SUBJECT: SAFETY EVALUATION REPORT FOR URANERZ U.S.A., INC., THE
RUTH ISLE PROJECT

SAFETY EVALUATION REPORT
SOURCE AND BYPRODUCT MATERIAL LICENSE
URANERZ U.S.A., INC.
RUTH ISL PROJECT
JOHNSON COUNTY, WYOMING
DOCKET NO. 40-8783
LICENSE NO. SUA-1401
OCTOBER 28, 1981

Preliminary Plant Layout
Figure 3C

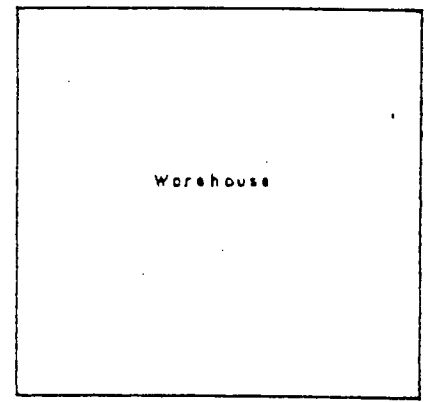
The applicant provided a facility floor diagram as indicated in Figure 30 to the application dated November 25, 1980, as revised September 1, 1981, showing the proposed layout for the process area; offices, the laboratory, and worker change and eating areas. The proposed layout is acceptable.

Figure 31
 Revised 10/8/81

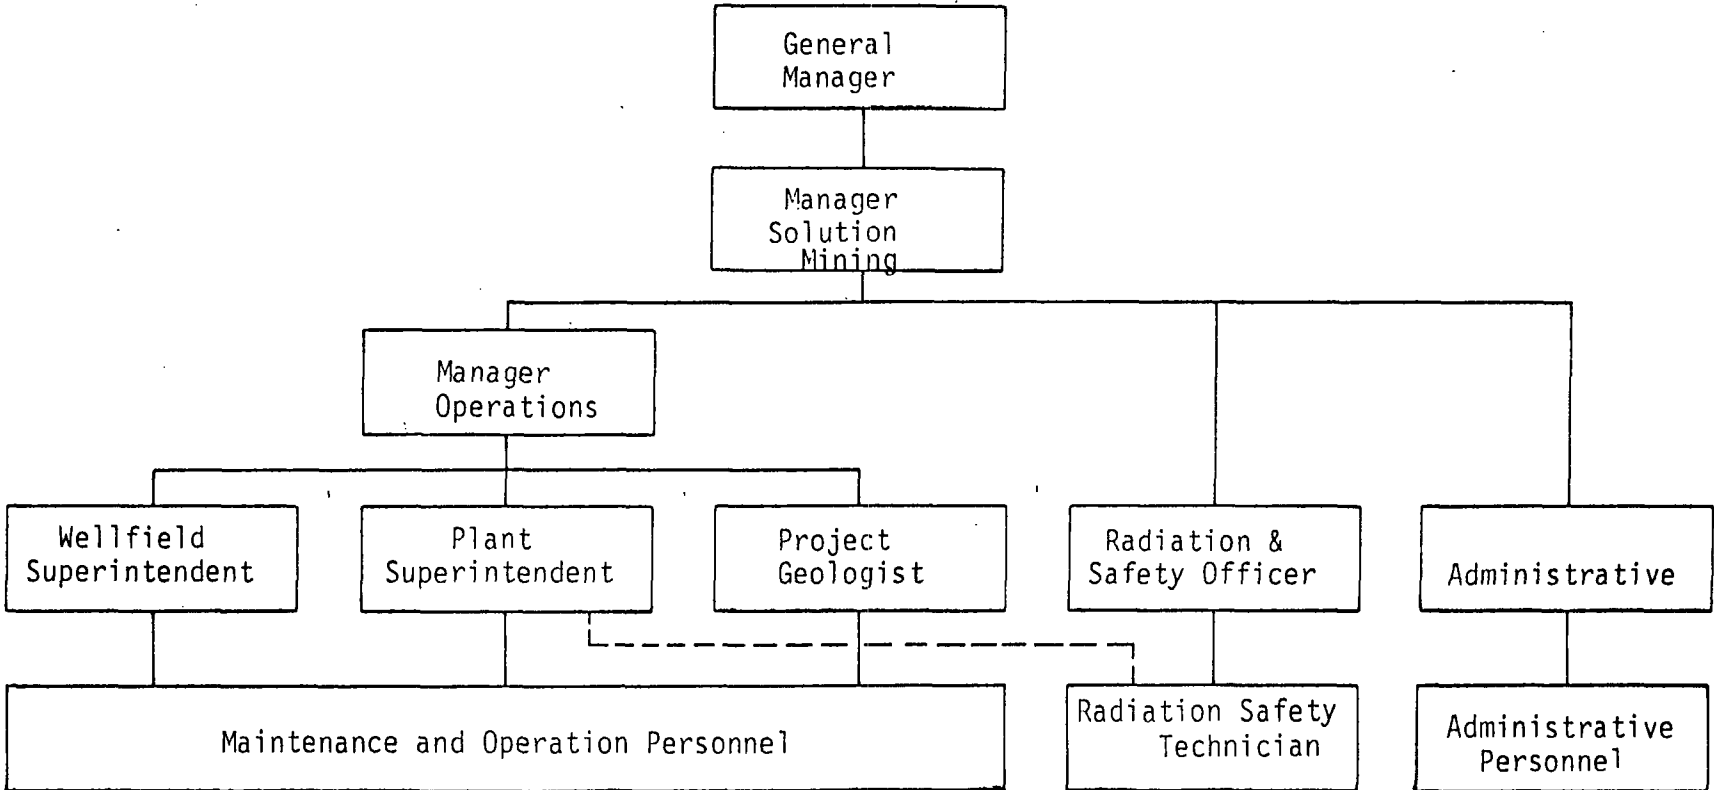
The staff has concluded that the proposed management organization is acceptable. The minimum qualifications of the site RST are presented later in the section. The staff recommends, but does not require, that the RST should not be assigned other production-related duties. The RST shall supervise any additional radiation safety staff assigned to the site. The RST may have other safety-related duties, such as responsibility for programs of industrial hygiene and fire safety.
